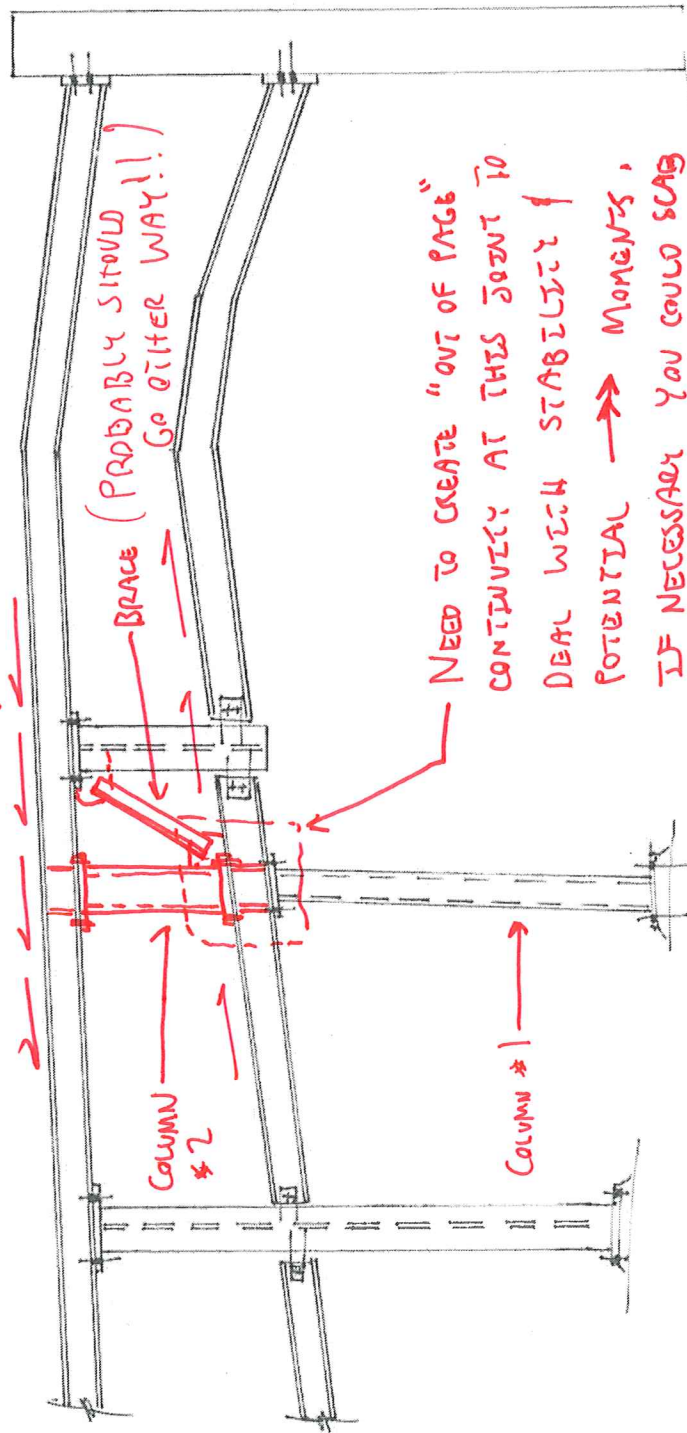
STIFF RESISTANCE
PROVIDED BY DECKING

NEED TO CREATE "OUT OF PAGE"
CONTINUITY AT THIS JOINT TO
DEAL WITH STABILITY &
POTENTIAL → MOMENTS,
IF NECESSARY YOU COULD SCAB
ON A MEMBER BYPASSING THE JOINT

CHANNEL SCABS?
ONLY IF THERE'S
ROOM FOR IT
